Access Compliance Report

Public Rights-of-Way

(Curb Ramps)

Intersection ID: 48857	Main Street: FENCELINE_DR	Cross Street: GREENFINCH_DR	Location: NE
ADA ID: D4069FE514BA	Ramp Type: PerpDiag	Initial Pass/Fail: Fail	Overall Compliance: No
Severity Score: 12.5			
Codes/Mitigation Info/Possible Solution		Field Measurements/Component Compliance

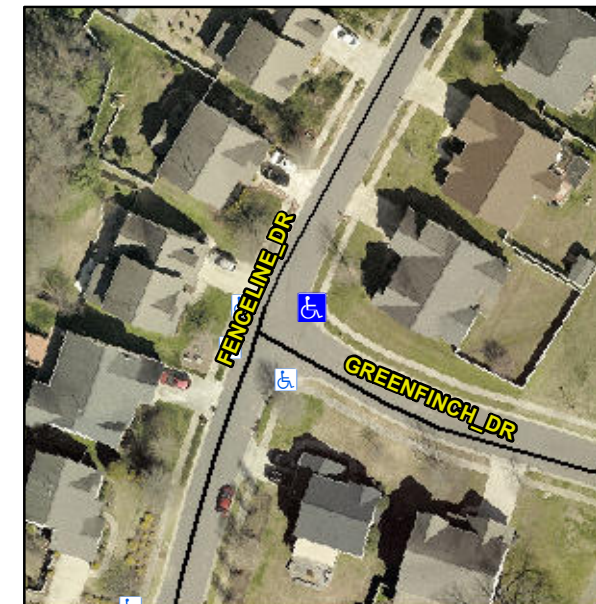
Compliance	Description	Data	Compliance	Description	Data
N/A	Ramp Length (in)	47.0	No	Ramp Slope (%)	9.5
Yes	Ramp Width (in)	48.0	Yes	Ramp XSlope (%)	1.3
N/A	Flare Type LT	N/A	N/A	Flare Type RT	N/A
N/A	Flare Slope LT (%)	N/A	N/A	Flare Slope RT (%)	N/A
N/A	Flare Traversable LT?	N/A	N/A	Flare Traversable RT?	N/A
N/A	Landing Length (in)	N/A	N/A	DWS Provided?	N/A
N/A	Landing Width (in)	N/A	N/A	DWS Contrast?	N/A
N/A	Landing Slope (%)	N/A	N/A	DWS Length (in)	N/A
N/A	Landing X Slope (%)	N/A	N/A	DWS Full Width?	N/A
N/A	Landing Curb? (Y/N)	N/A	N/A	DWS Offset (in)	N/A
N/A	Shared Landing?	N/A			
N/A	Gutter Ponding?	N/A	N/A	Gutter Slope (%)	N/A
N/A	Gutter Lip Ht (in)	N/A	N/A	Gutter X Slope (%)	N/A
N/A	Painted X Walk1?	No	N/A	Painted X Walk2?	No
	X Walk 1 Direction	To NW		X Walk 2 Direction	To SW
N/A	X Walk 1 Width (in)	N/A	N/A	X Walk 2 Width (in)	N/A
	X Walk 1 Slope (%)	0.6		X Walk 2 Slope (%)	0.0
	X Walk 1 X Slope (%)	0.7		X Walk 2 X Slope (%)	0.9

N/A	Ramp inside XWalk1?	N/A	N/A	Ramp inside XWalk2?	N/A
	Road Slope (%)	0.1	N/A	Clear Space?	N/A
	Road X Slope (%)	1.8	N/A	Clear Space to XWalk (in)	N/A
N/A	Any Obstructions?	N/A	N/A	Storm Grate/Utility Hazard?	N/A
	Obstruction Type			Storm Grate/Utility Type	
		N/A			N/A
		Yes		Surface Condition? (G/P)	Good

Remove & Replace Curb Ramp With Two New Directional Ramps or Equivalent.
